**Re: Proposal to Amend the Curtis Drain Engineer's Report**

APPENDIX A  
AMENDED CURTIS DRAIN REPORT

**Re: Amended Curtis Drain Report**

## CURTIS DRAIN PLAN

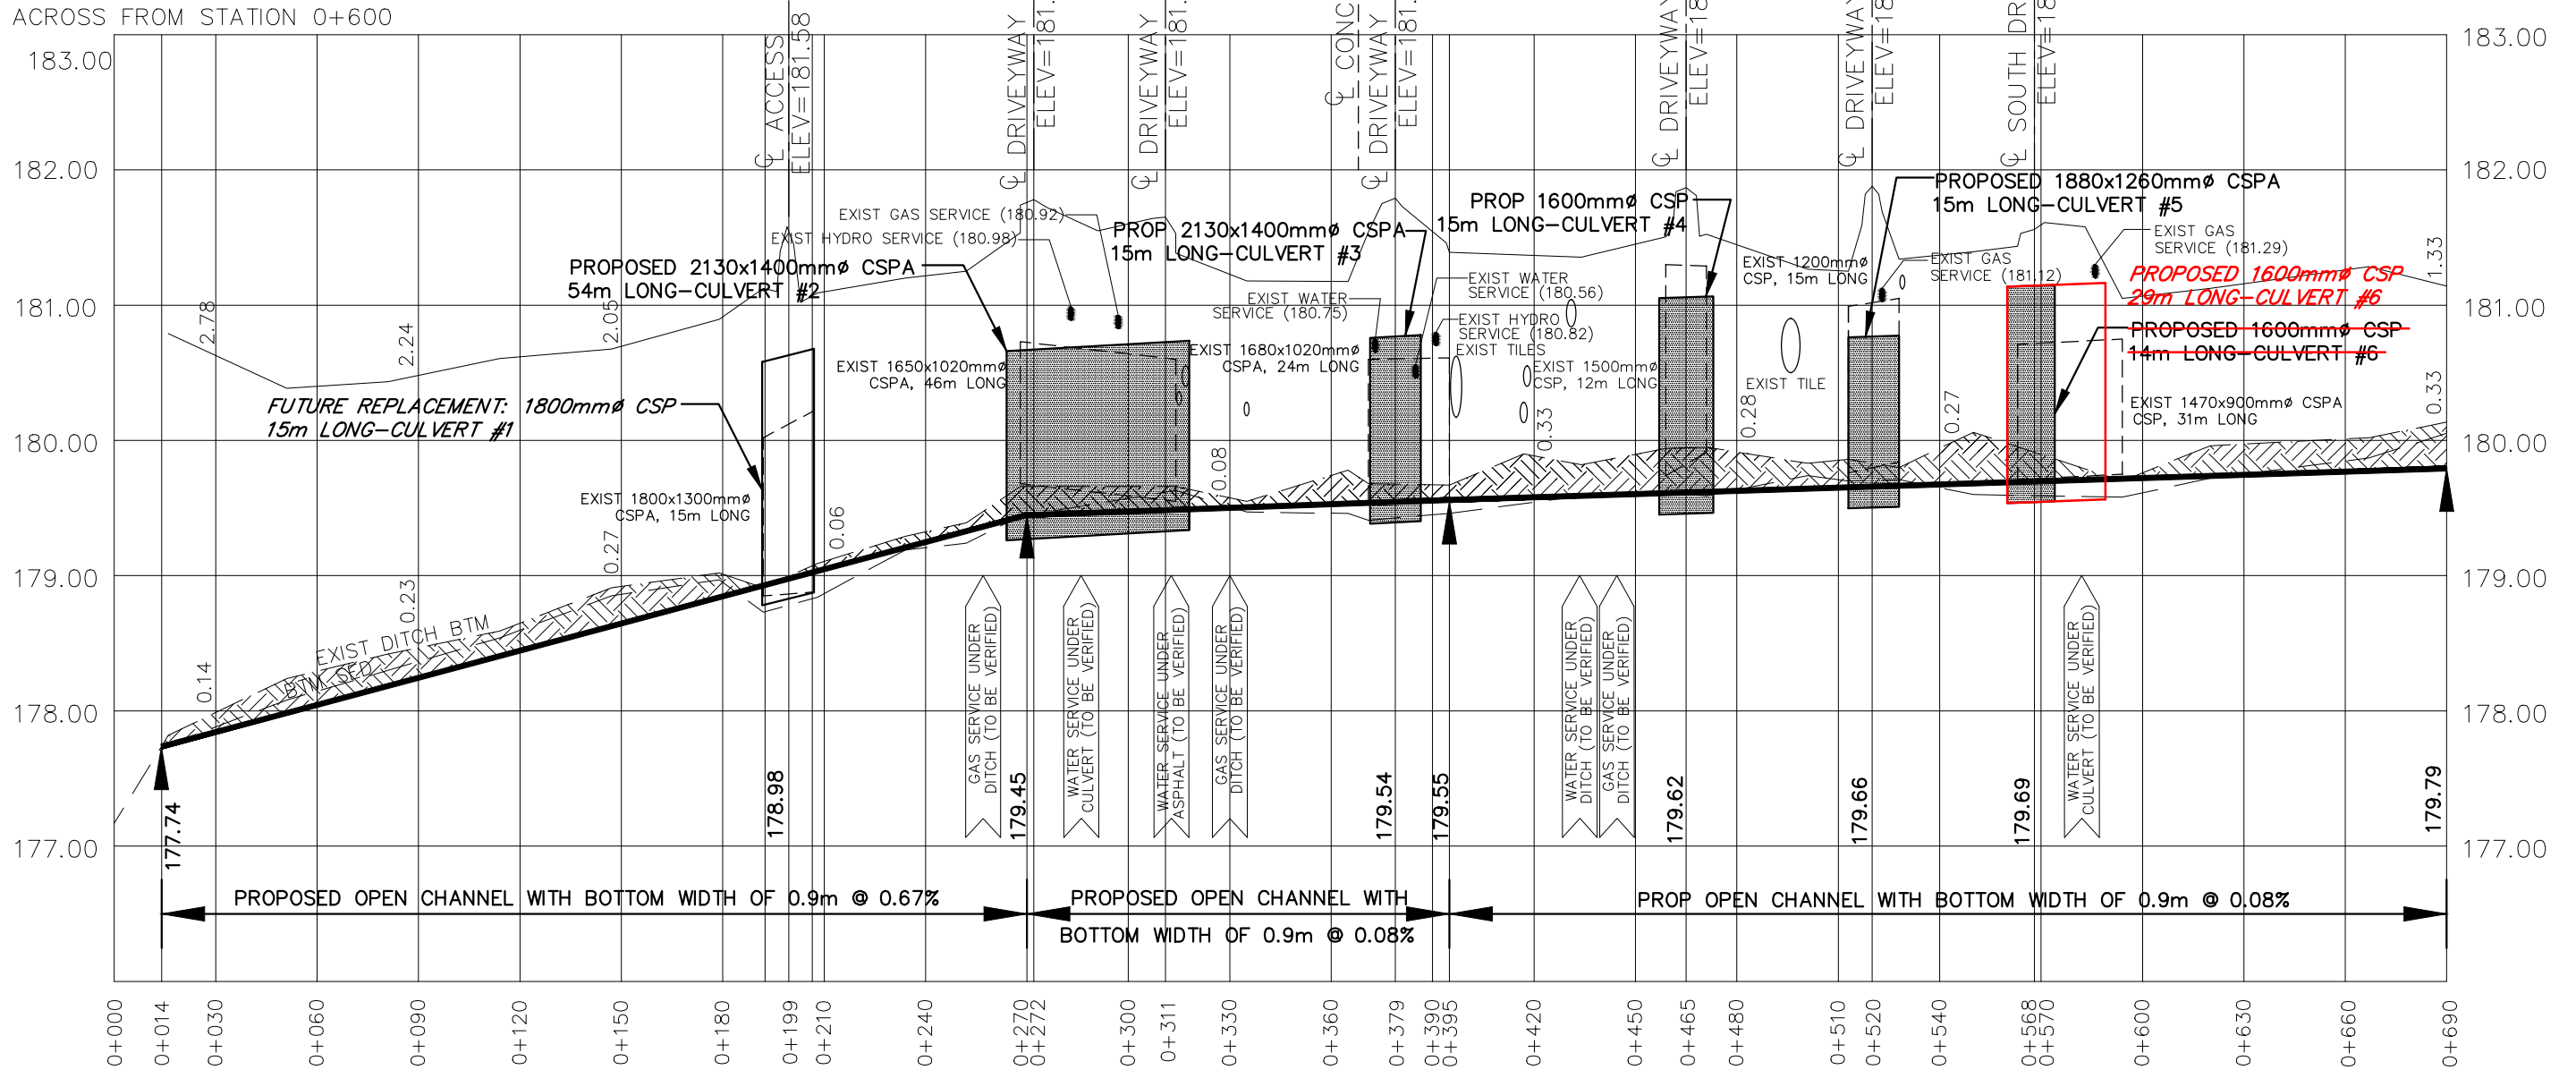
APPROVED	NO.	REVISIONS	DATE	BY
J. WARNER				
CHECKED	1	AMENDED	AUG. 23, 2021	JW
B. VAN RUITENBURG	1	FINAL REPORT	JUNE 1, 2020	JW
DRAWN	SCALE: 1:7500			
J. WARNER

DRAWING NAME:  
Curtis Drain Profile 3

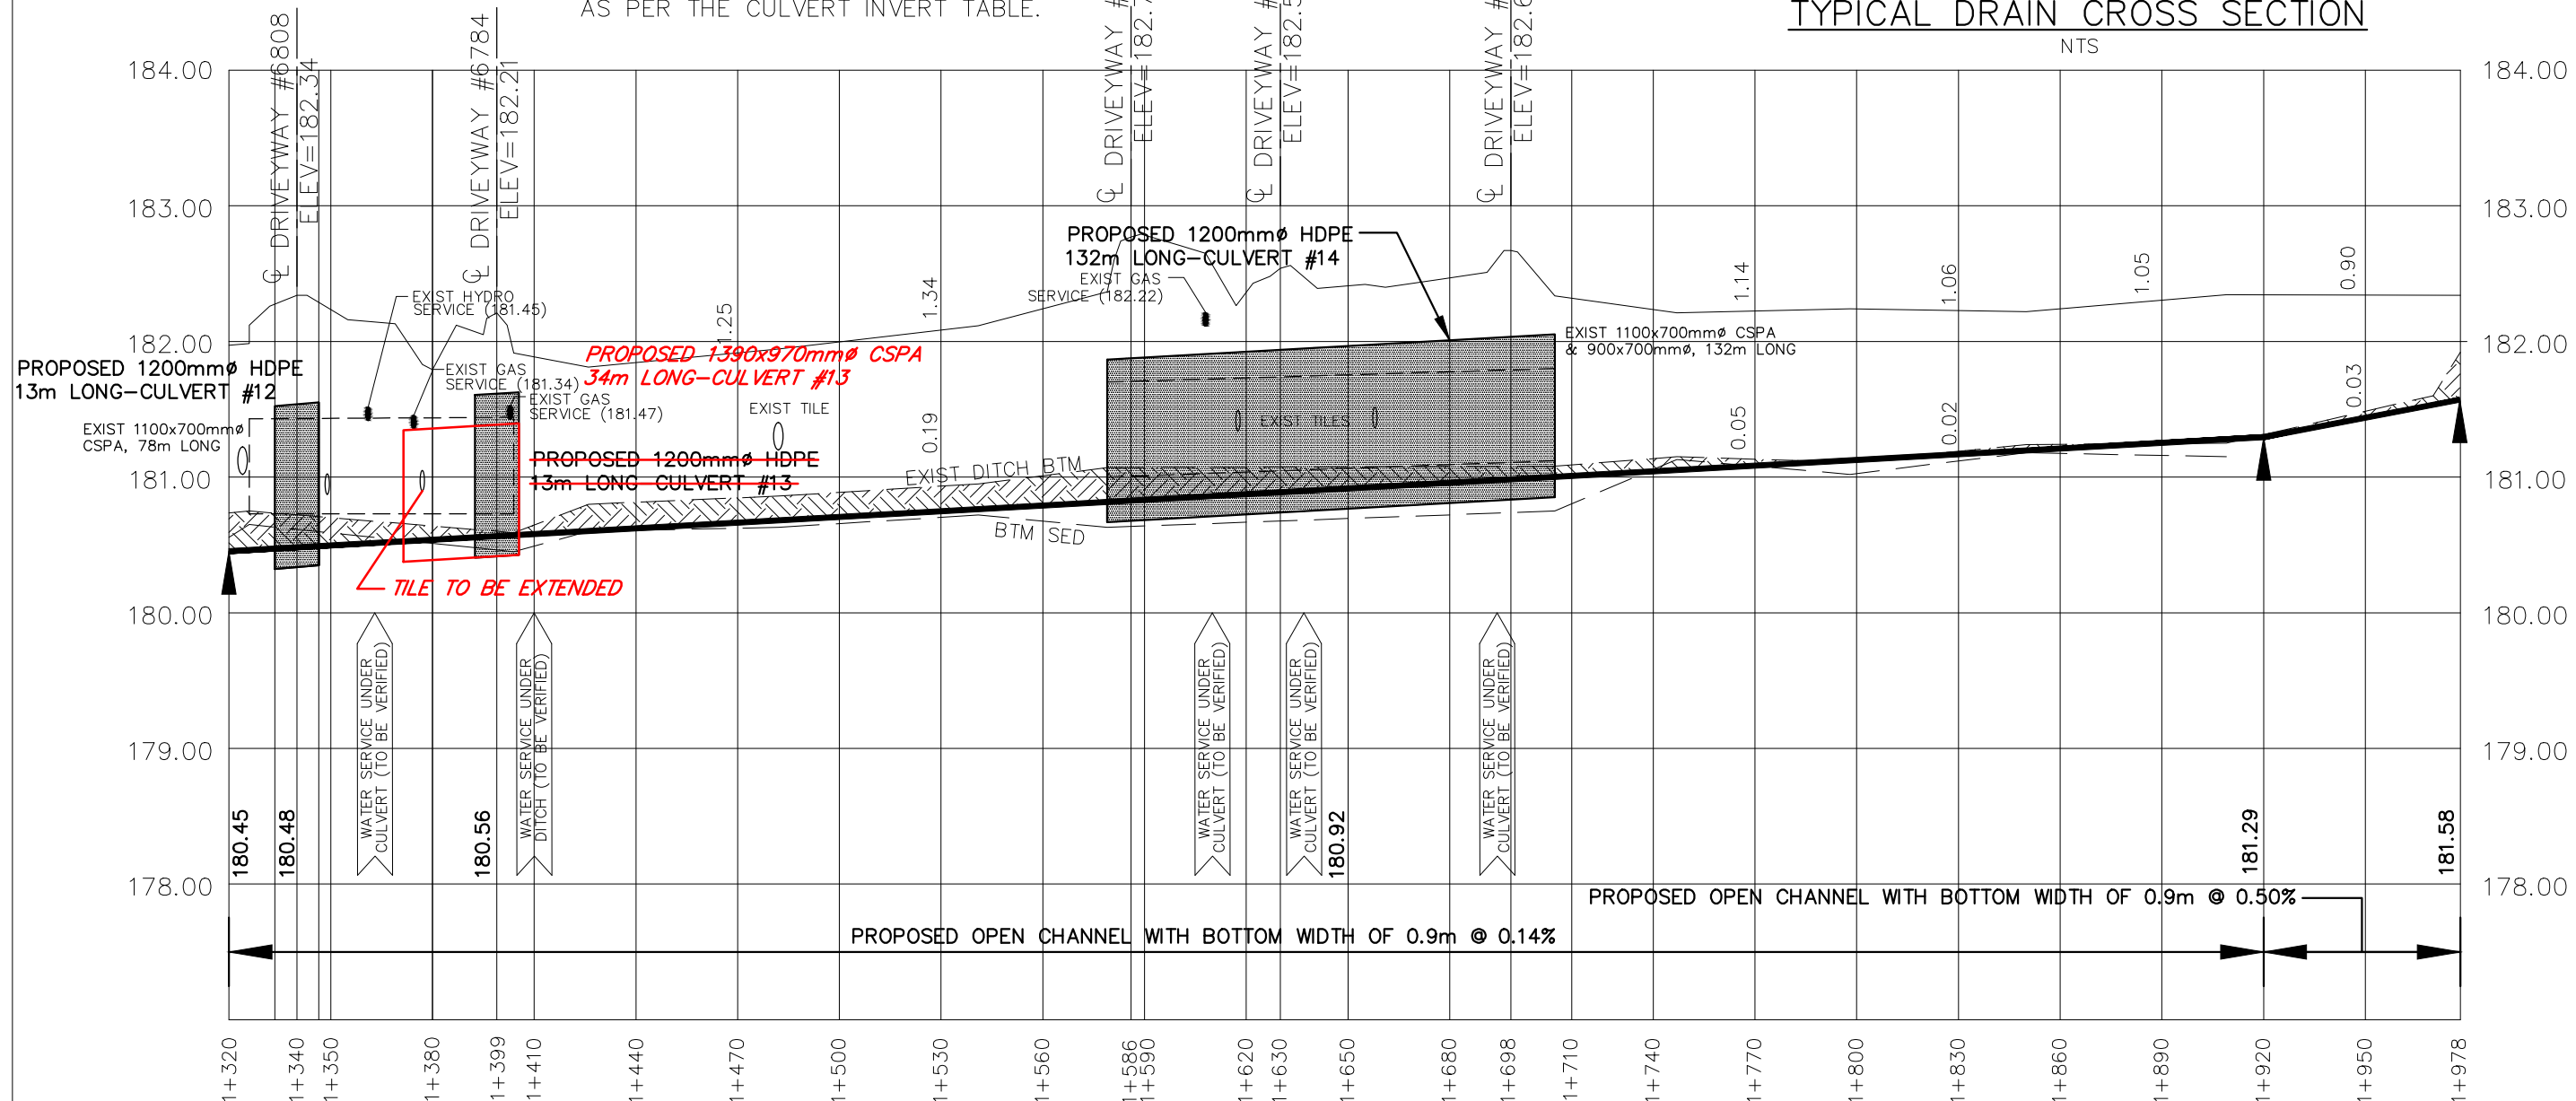
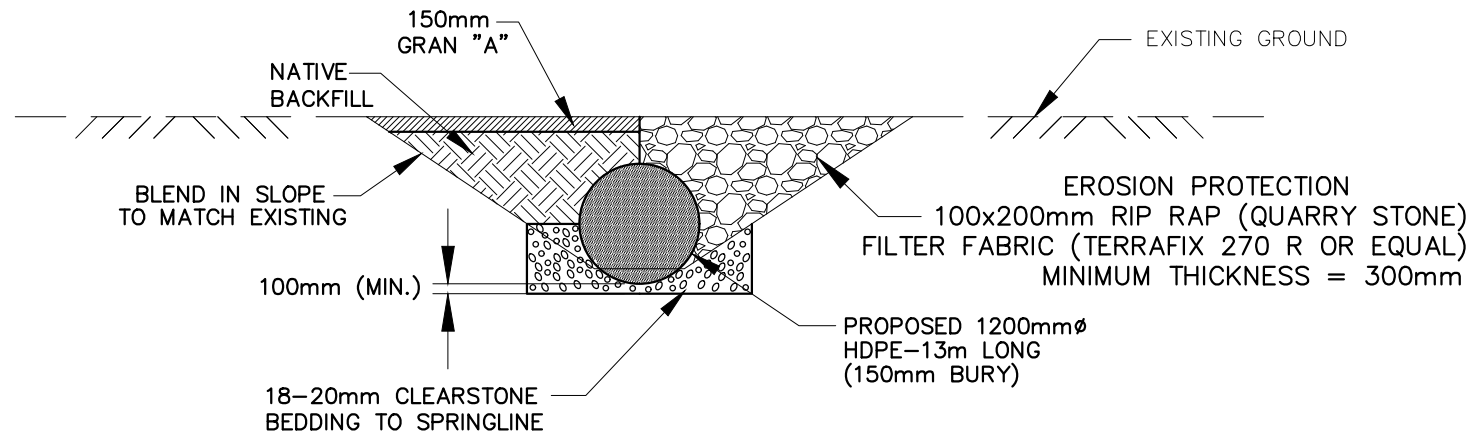
APPROVED	NO.	REVISIONS	DATE	BY
J. WARNER	2	AMENDED	AUG. 23, 2021	JW
CHECKED B. VAN RUITENBURG	1	FINAL REPORT	JUNE 1, 2020	JW
DRAWN J. WARNER	SCALE: 1:2,000			
0 20 40 60m
